RE: Three Sisters, LLC DBA Wildflower onsite consumption change to small structure "Kiosk"

Dear Honorable members of the Marijuana Control Board,

1 Site Diagram
1" = 20'-0"

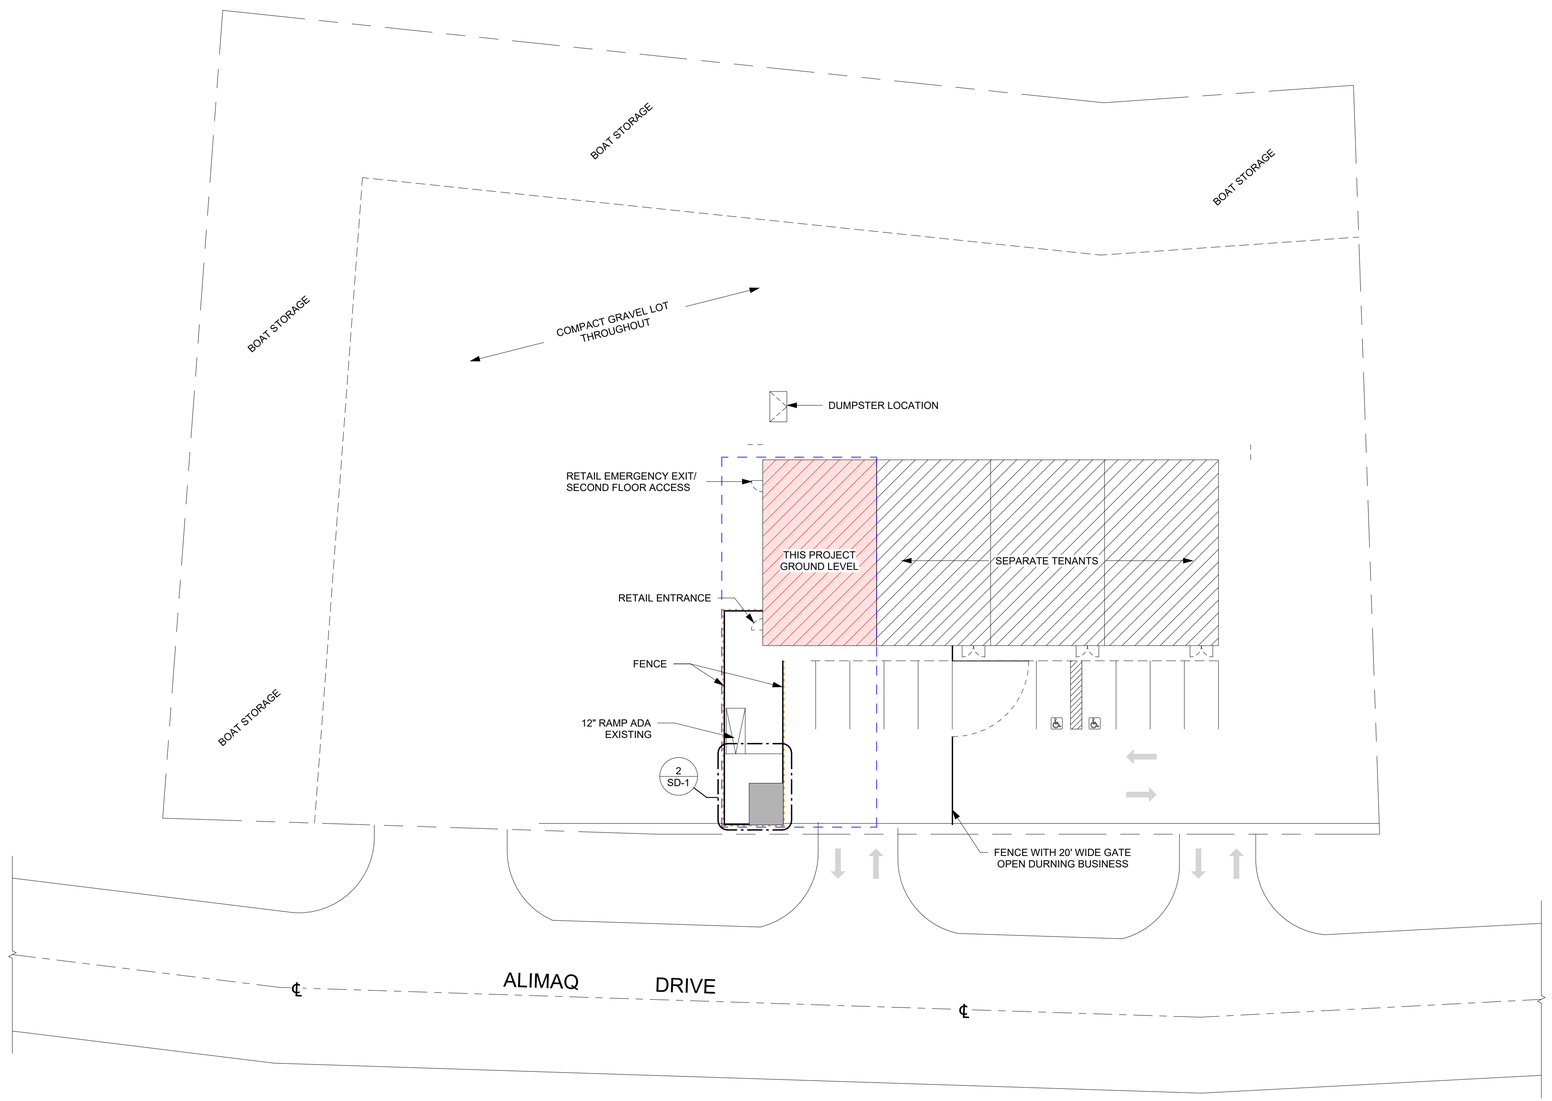
- MCB Concern: The site plan layout showing the fence surrounding the onsite consumption area will cut off traffic flow in and out of the parking lot. **JDW:** The site plan was confusing, and we understand the concern. After the last meeting my office and licensee Janiese Stevens worked closely with Determine Design to work on an accurate and detailed site plan for the proposed use (attached). Photos below of driveways, ditches and fence for clarity.

2 KIOSK PLAN
1/4" = 1'-0"

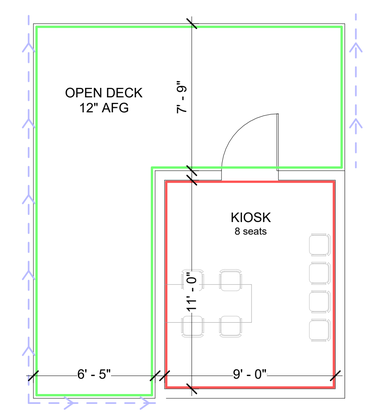
- MCB Concern: Who is in the small structure? What are they doing? How many people are in there? What is the mode of operation? Is there a service counter? We need answers to these questions. **JDW:** As mentioned infra, there is a maximum capacity of 8 people in the small structure, not taking into account the customers sitting on the outdoor deck. Any person in the small structure or on the outdoor deck will be there to utilize the onsite consumption area while enjoying the Kodiak summer as this onsite consumption area will only be open during the summer months, potentially spring and fall as well if the weather allows. Customers who want to gain access to the onsite consumption area will purchase onsite consumption stickered product from the retail store before being allowed access to the onsite consumption area. Customers have their ID verified at the retail point of sale dedicated to onsite consumption, only products intended for onsite consumption will be allowed in the consumption area, products will have particular stickers or color-coded packaging that will allow for an employee to easily recognize marijuana or marijuana products that were purchased for the consumption area and marijuana and marijuana products that were not. All marijuana or marijuana products that are left by customers in the consumption area will be quickly cleaned up and disposed of in a manner compliant with regulations. No smoking is allowed on the outdoor patio. The mode of operations for this change is detailed in the MJ-15 operating plan change and corresponding MJ-28b onsite consumption endorsement operating plan that was submitted to AMCO.

- MCB Concern: We need clear information on how the small structure would function as an on-site consumption area, it's not clear, there is no furniture, no counter, there's no nothing, it's just a box with a door. **JDW:** We have worked with the licensee and their architect, the new plans and photos provided should give the board a clear understanding of the intent and layout of this proposed onsite consumption endorsement.
